# UNITED STATES PATENT AND TRADEMARK OFFICE

APPLICATION NO.	FILING DATE	FIRST NAMED INVENTOR	ATTORNEY DOCKET NO.	CONFIRMATION NO
09/972,448	10/06/2001	Koya Suzuki	5000-4960	4076
7590 11/05/2003		EXAMINER		
MORGAN & FINNEGAN, L.L.P. 345 Park Avenue			GARCIA, ERNESTO	
New York, NY 10154			ART UNIT	PAPER NUMBER
			3679	
		DATE MAILED: 11/05/2003

## **DETAILED ACTION**

【図8】

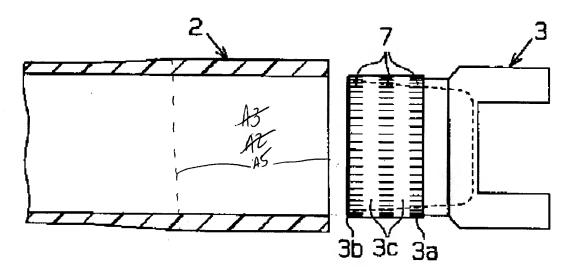
Regarding claim 1, Yasuchika et al. disclose in Figures 7 and 8 a first member 3, and second member 2. The first member 3 has a serration portion 7b provided at a pressure insertion end portion A3 of the first member 3. The second member 2 has a pressure insertion portion A5. The first member 3 has a surface contact portion A6 at location adjacent to the serration portion 7b. The surface contact portion A6 includes a step portion A7 provided between a leading end portion A8 of the pressure insertion end portion A3 and the serration portion 7b. A diameter A9 of the step portion A7 is set between a diameter A10 of the pressure insertion portion A5 and a diameter A11 of the serration portion 7b. The first member 3 is a metal yoke of a propeller shaft and the second member 2 is a fiberglass reinforced plastic cylinder of the propeller shaft (see English abstract).

Regarding claim 3, the serration portion **7b** is provided to an outer circumferential surface of the pressure insertion end portion **A3**.

Regarding claim 6, after the second member 2 is joined to the serration portion **7b**, the step portion **A7** is in non-contact with the second member **2**.

Regarding claim 7, the first member 3 has a chamfering portion 3b extended from the leading end portion A8 to the step portion A7.

Regarding claim 15, the step portion **A7** is formed cylindrically between the leading end portion **A8** and the serration portion **7b**.
